June 12, 2014

Oregon State University  
Capital Projects Contract Administration  
Agricultural Systems Management Center

### ADDENDUM NO. 2

**FOUNDATION PLAN**

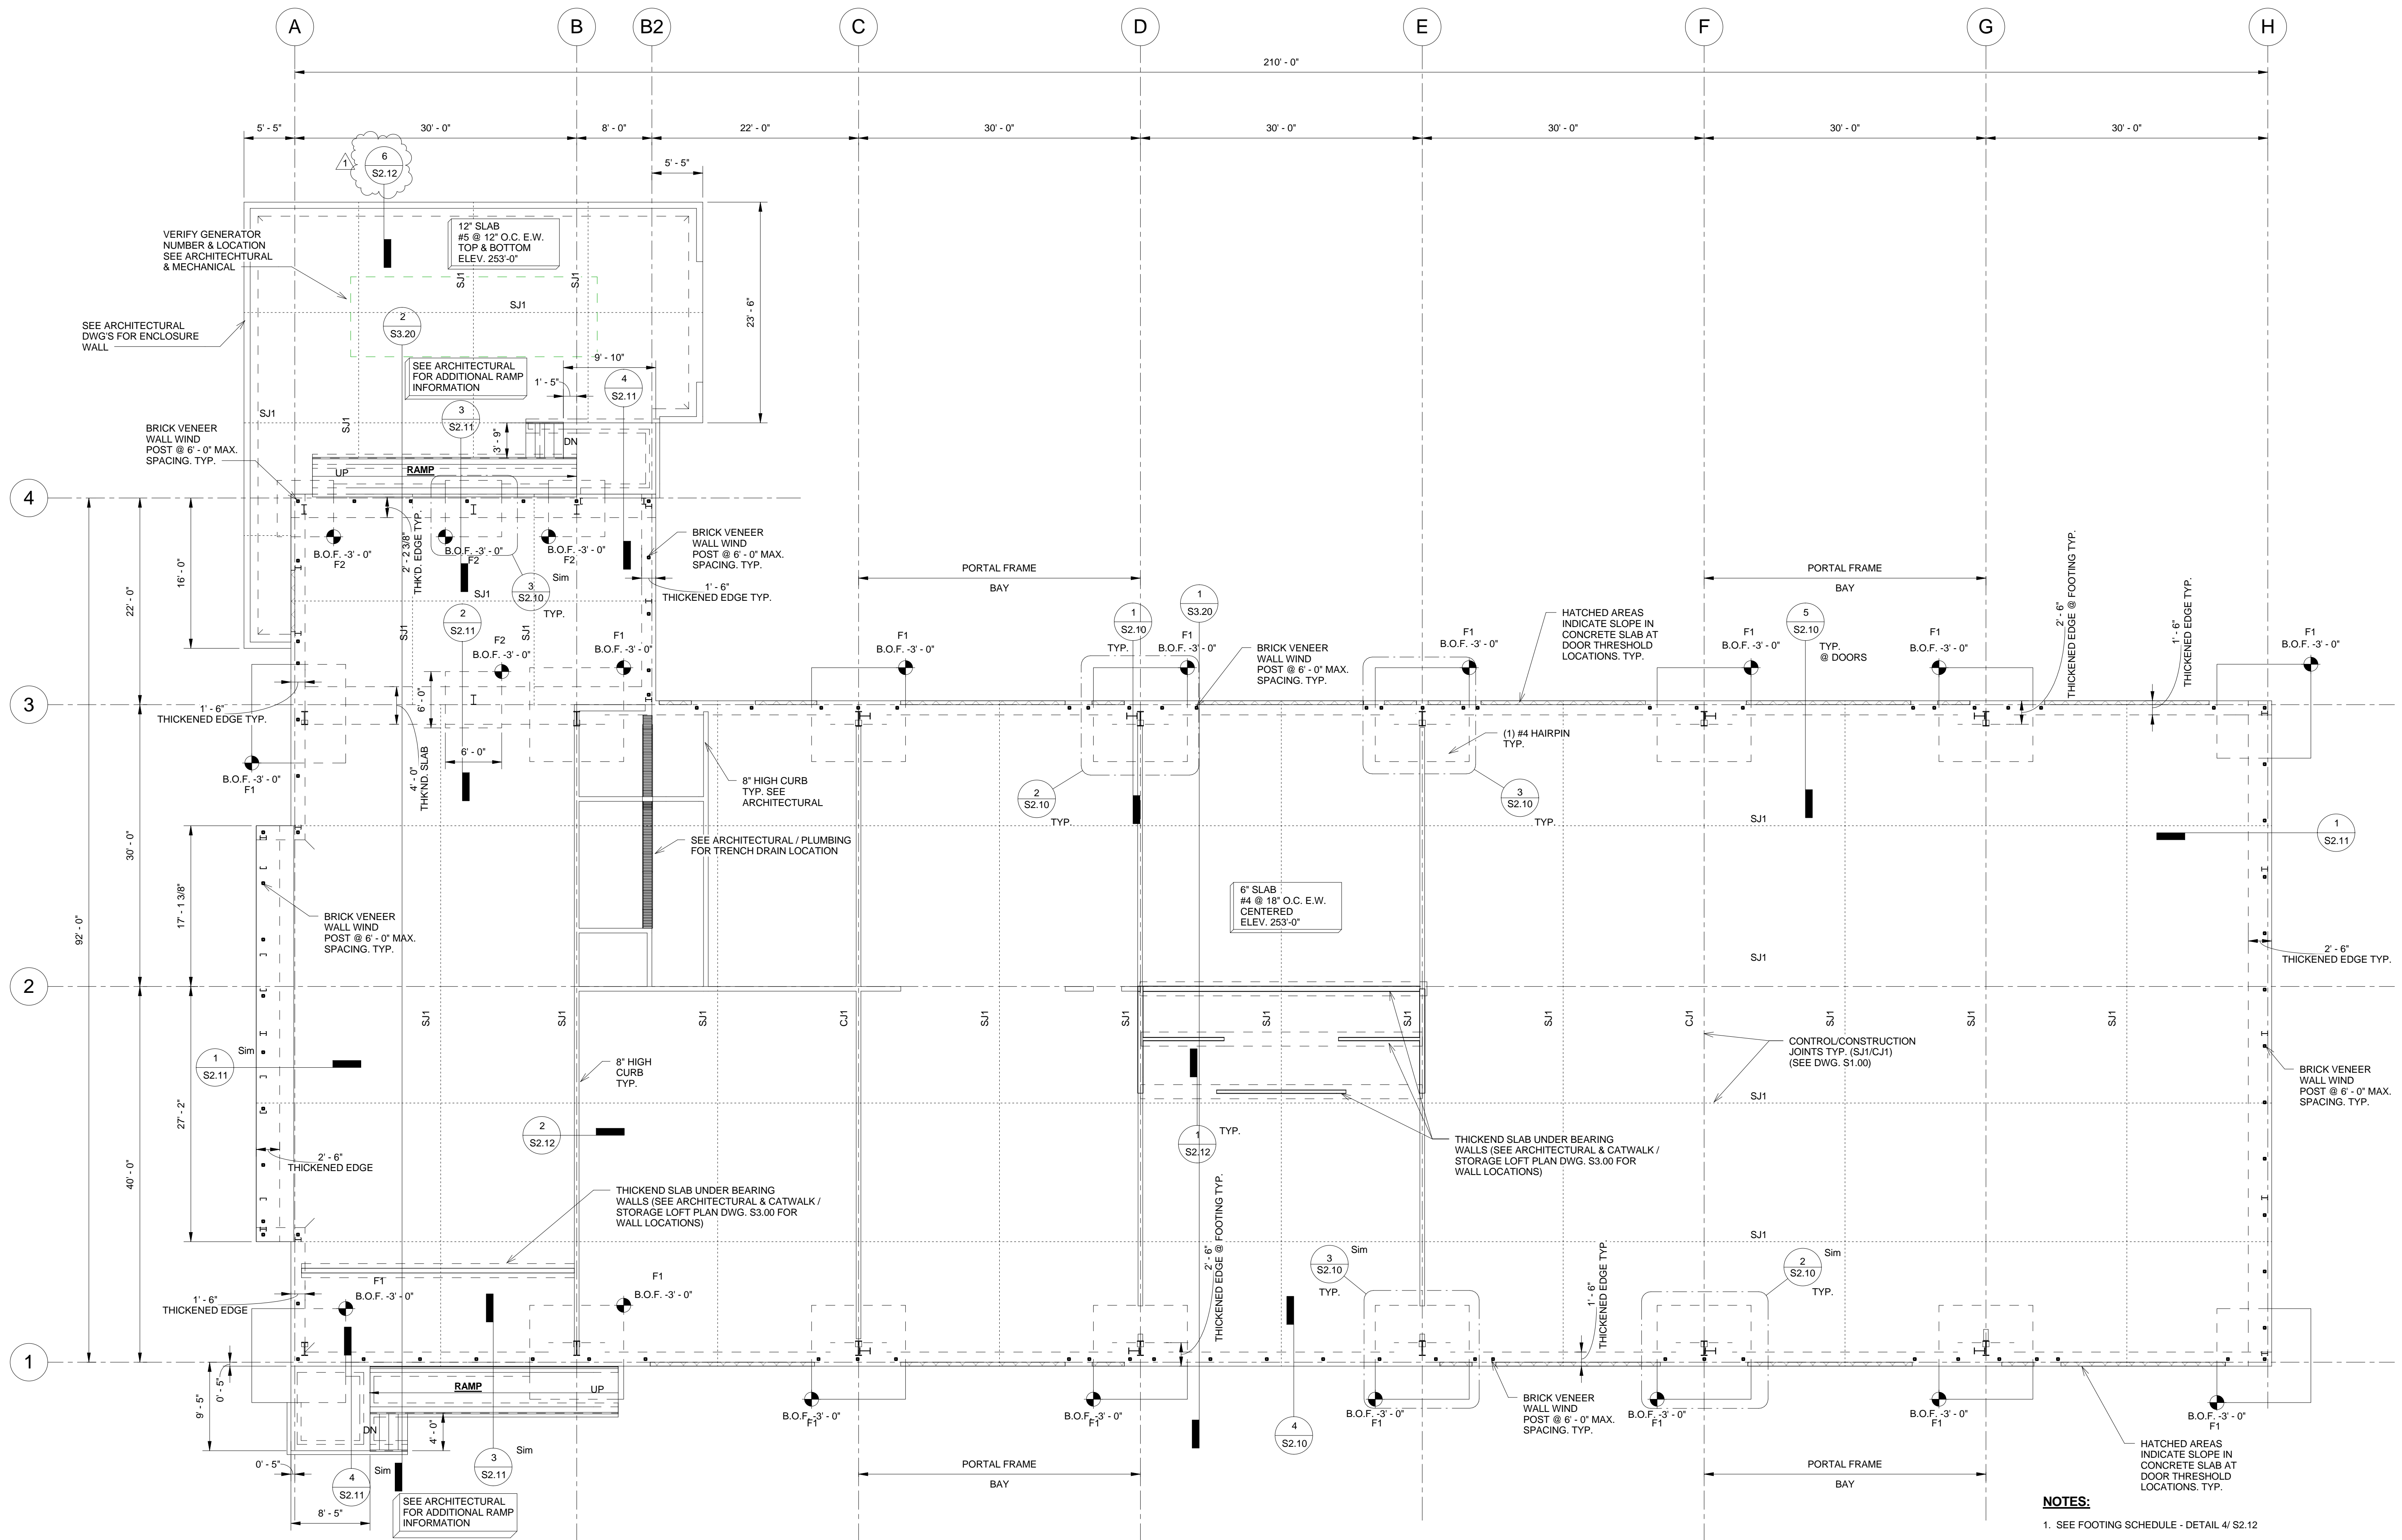
- Item 29      Structural Working Drawing Sheets:
  - A. Replace five (5) Structural Working Drawing Sheets: with the attached: S2.0 Foundation Plan, S2.10 Foundation Details, S2.11 Foundation Details, S2.12 Foundation Details, S3.10 Catwalk Framing Details.

**E1.1R**  
 SHEET OF

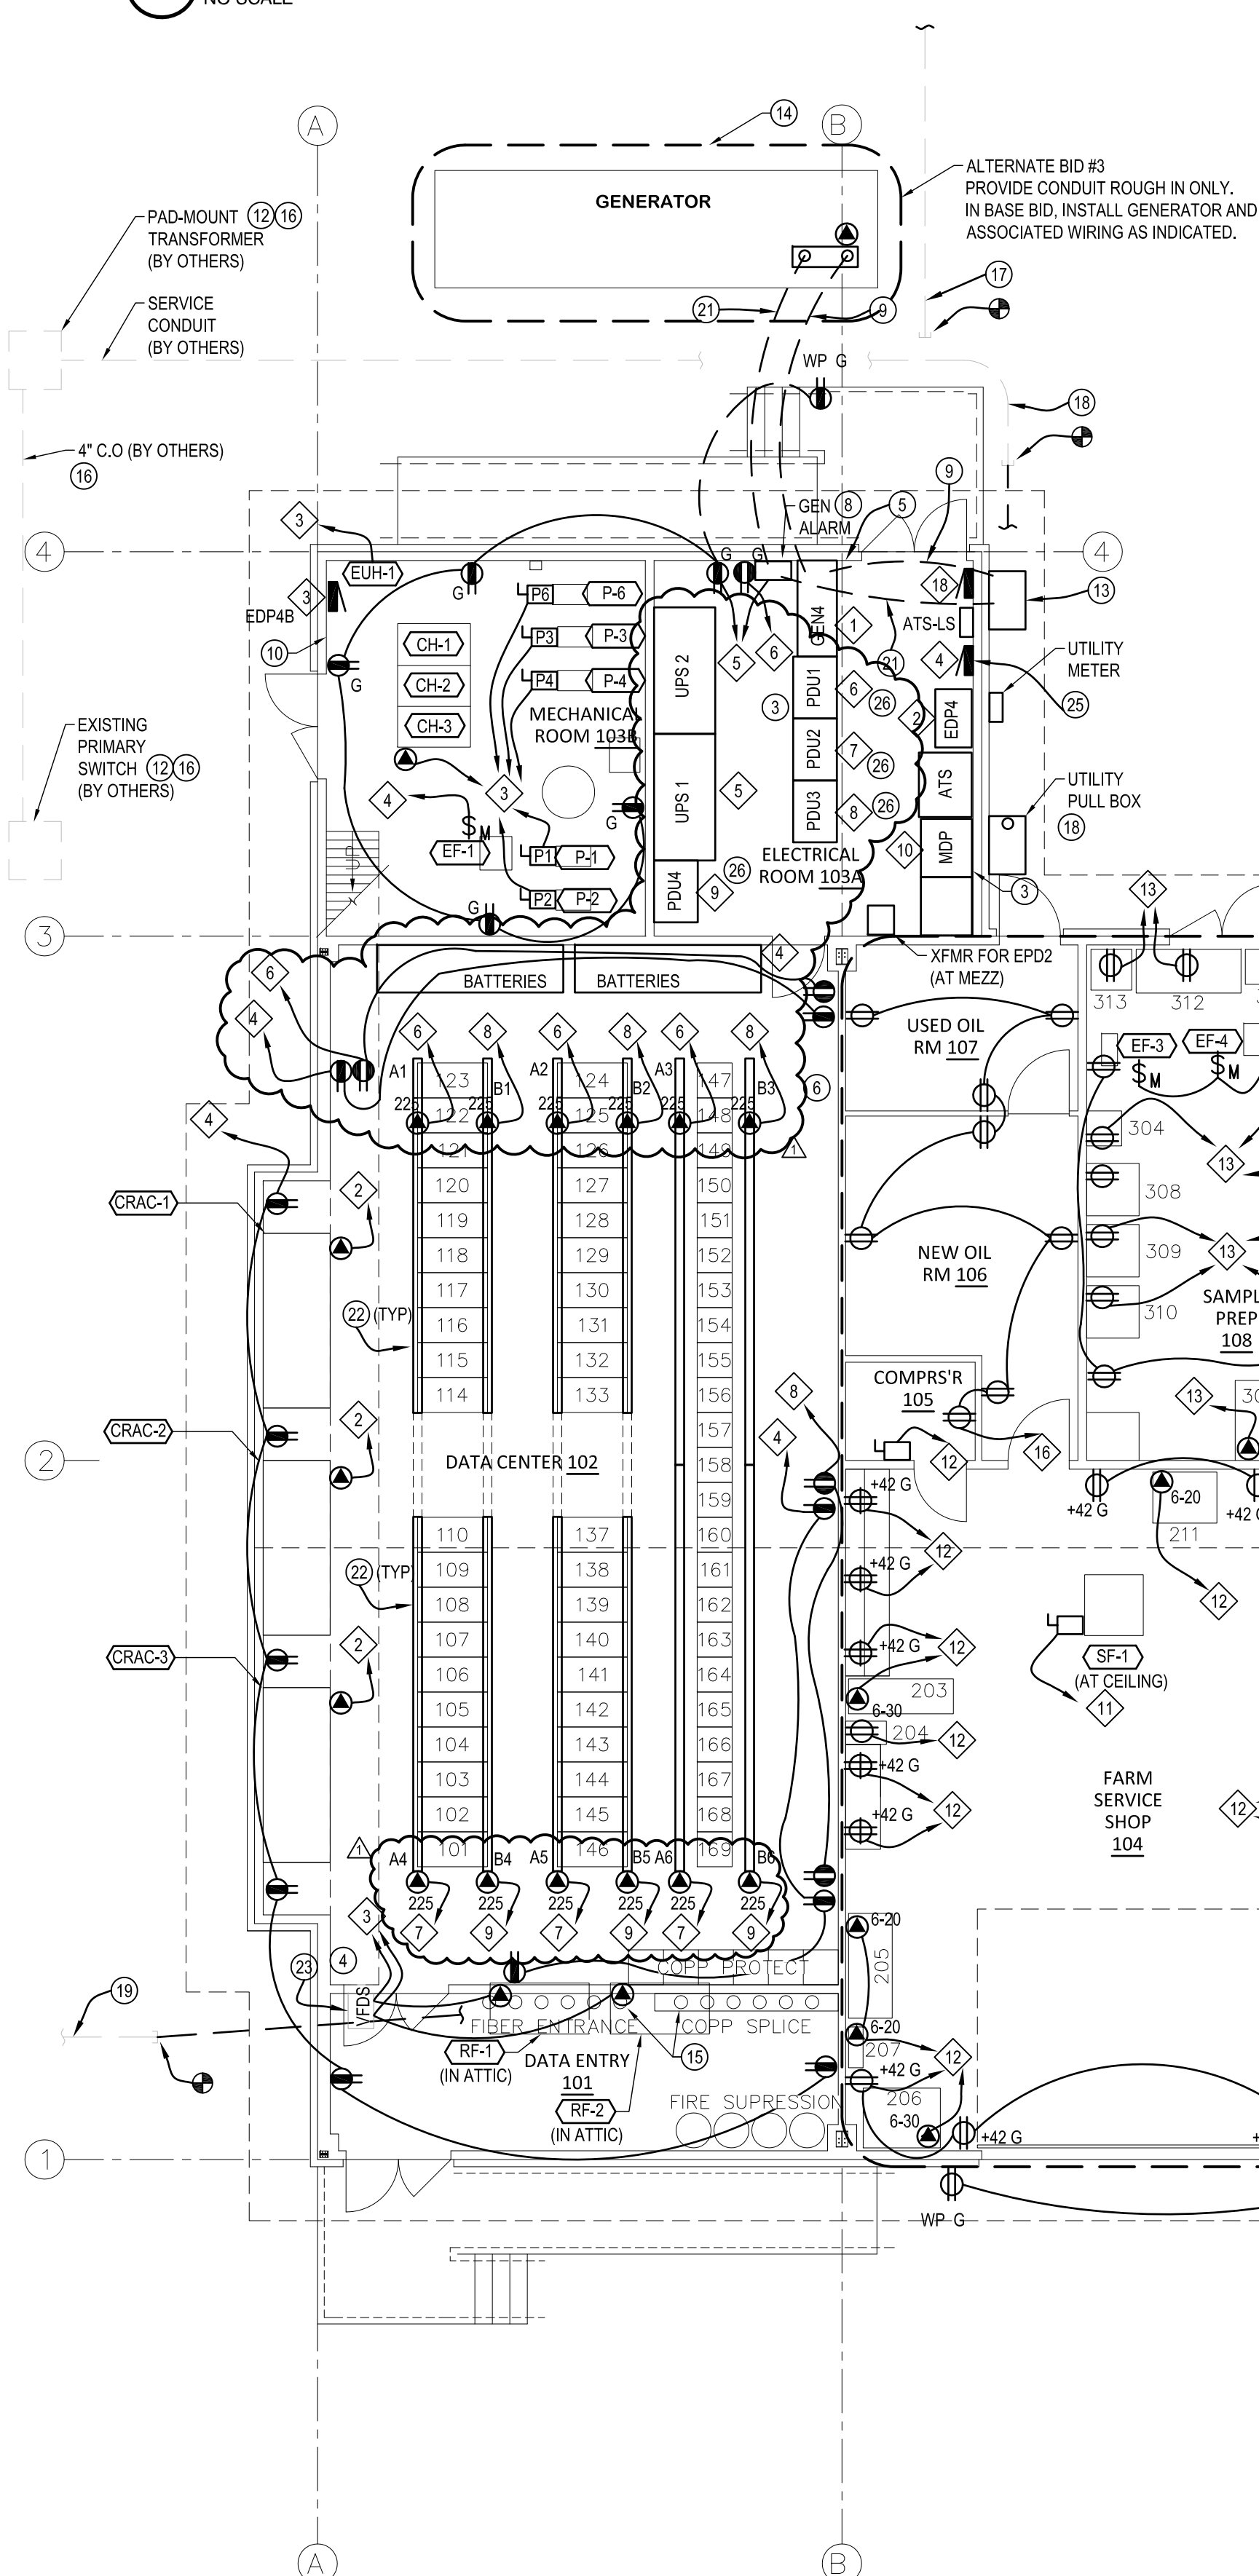
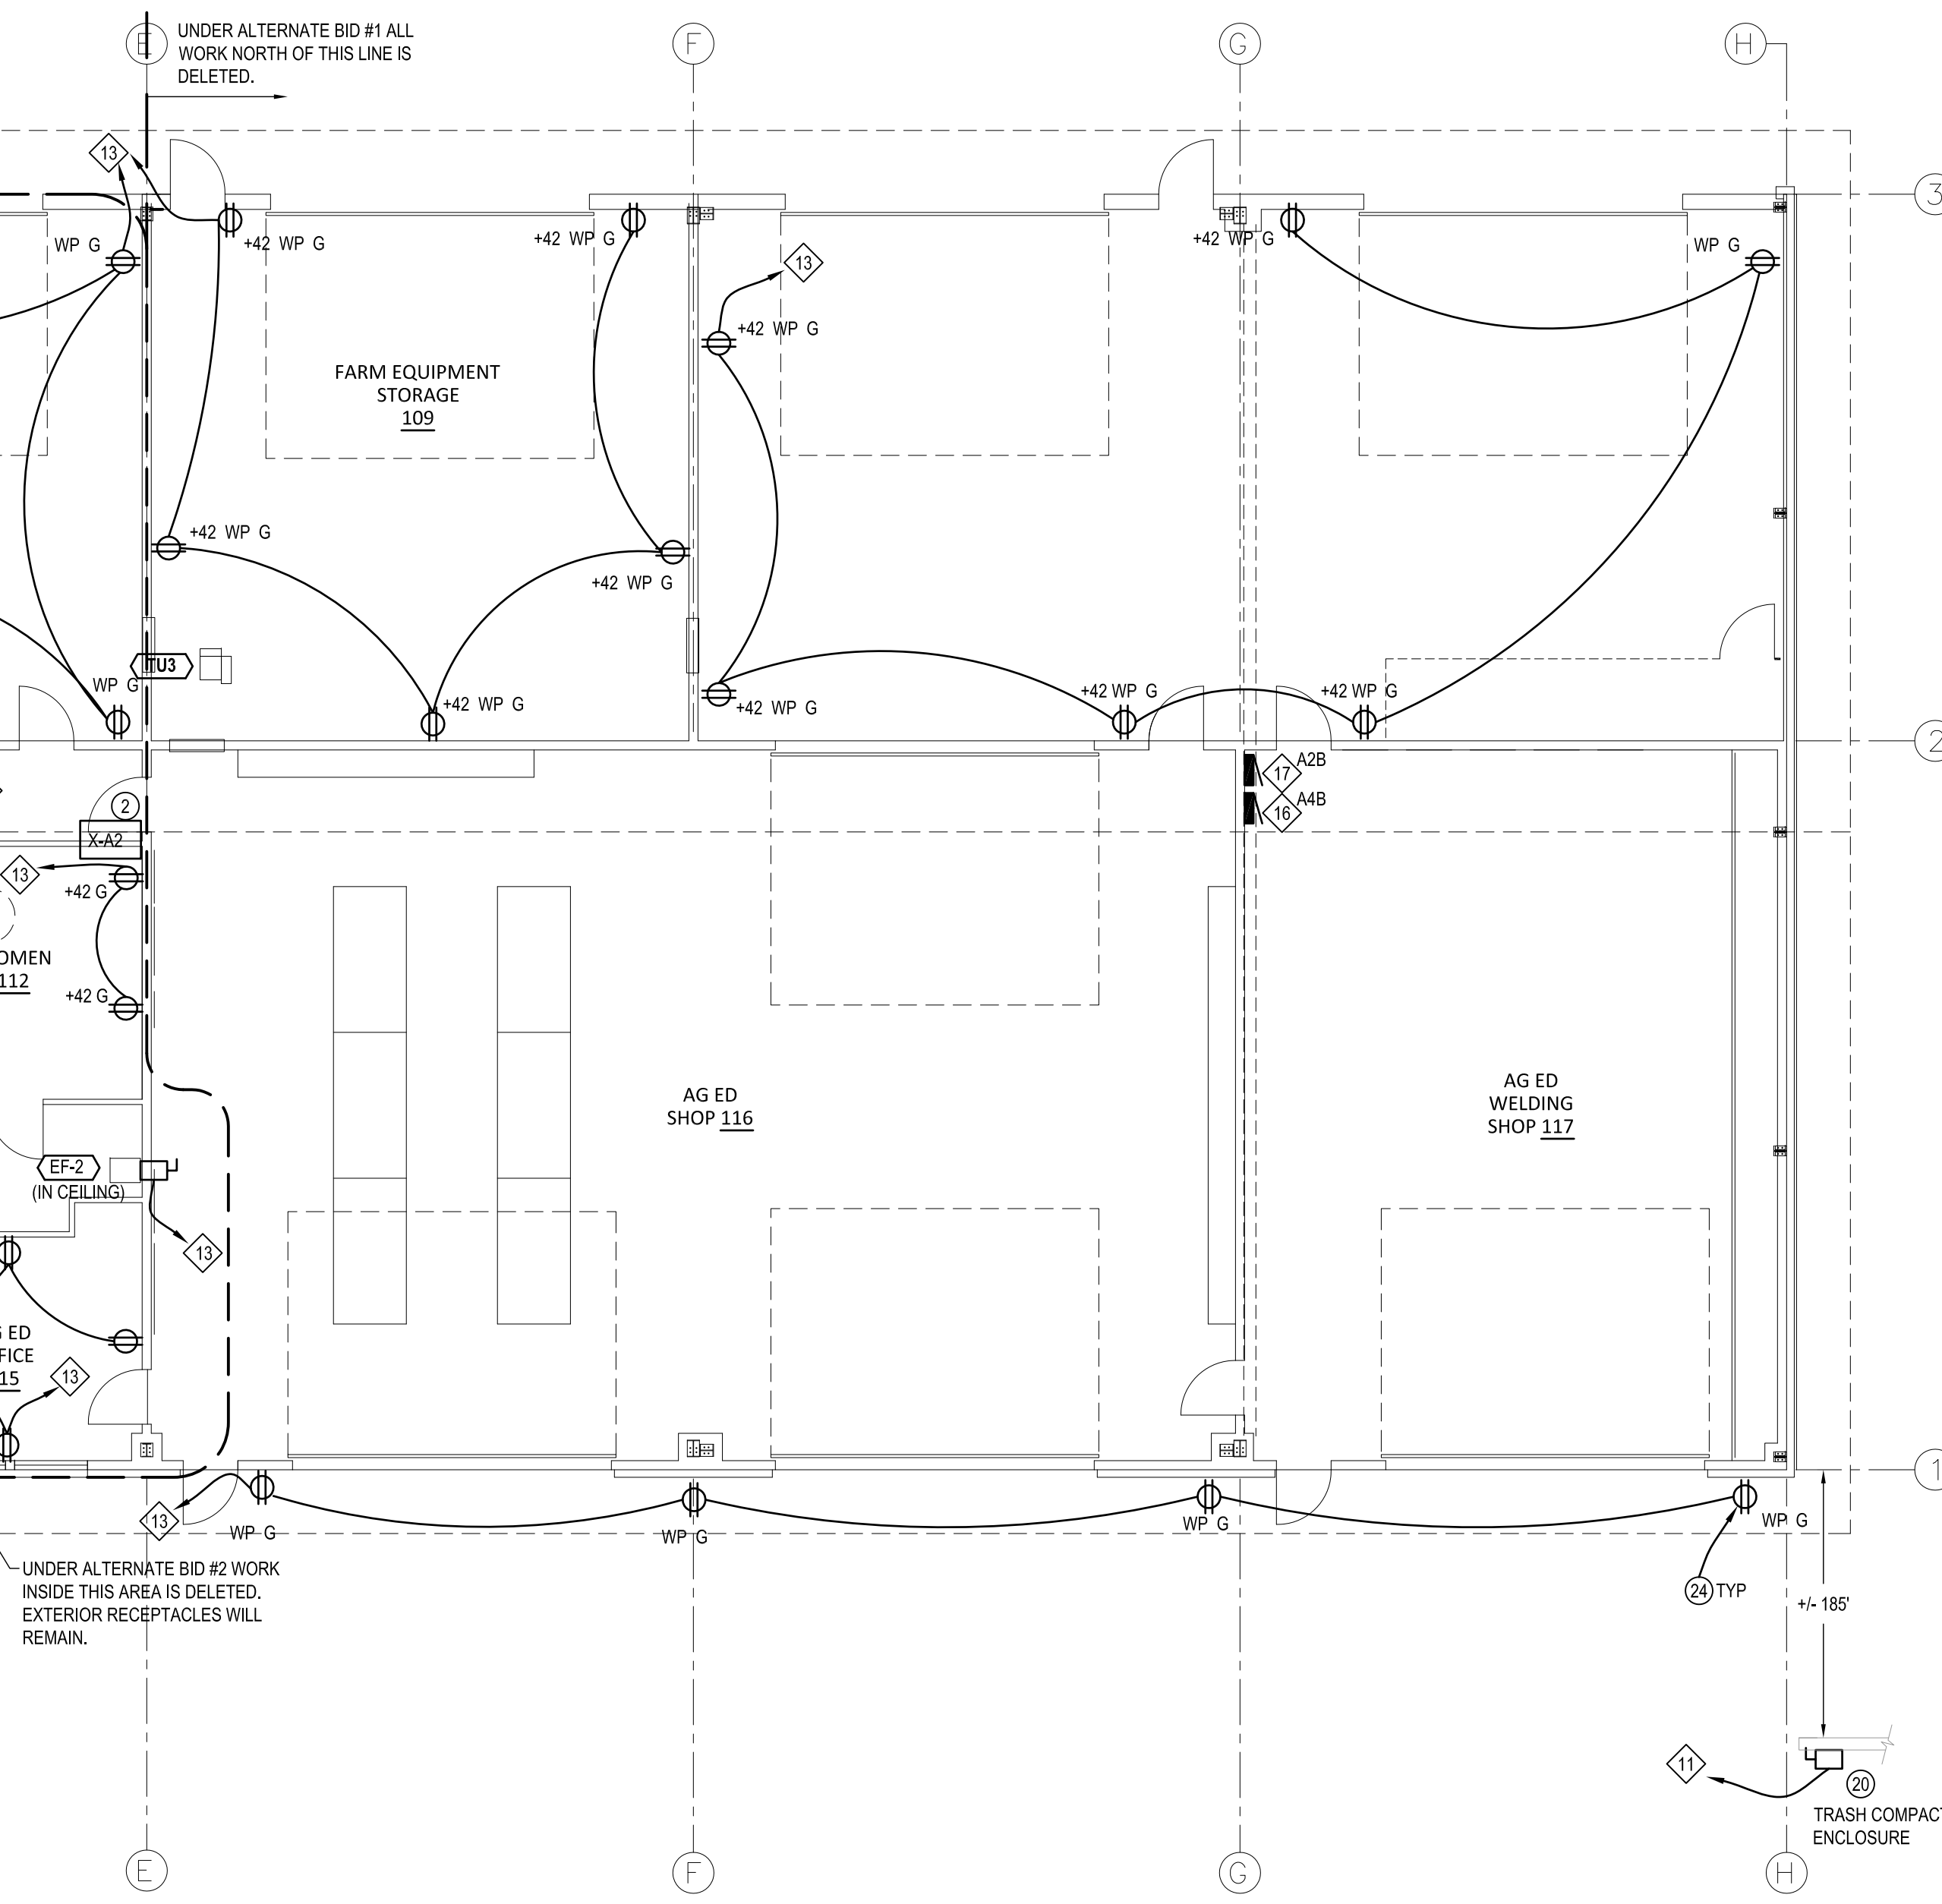
- Item 33      Sheet E1.1 Electrical Floor Plan
  - A. Replace last sentence in Note #13 with the following: See specification section 26 05 37 for generator interface box requirements.

- B. Revise UPS and PDU layout and quantity per attached drawing E1.1R. Revise Bus duct home runs per attached drawing E1.1R, dated 06/12/14.
- C. Add the following sentences to Note #17: Existing conduit from HAMB transfer switch terminates at Panel EDP2 location. See one line diagram for wiring requirements.
- D. Add the following sentences to Note #19: Existing conduit from HAMB communication cabinet terminates at ASMC data rack location. Coordinate locations with Owner's Authorized Representative (OAR).
- E. Add the following sentences to Note #20: Change to read as follows: "Provide 1" conduit from panel F4 to northeast corner of building for future trash compactor. Extend conduit beyond concrete apron, cap and install monument indicating location."
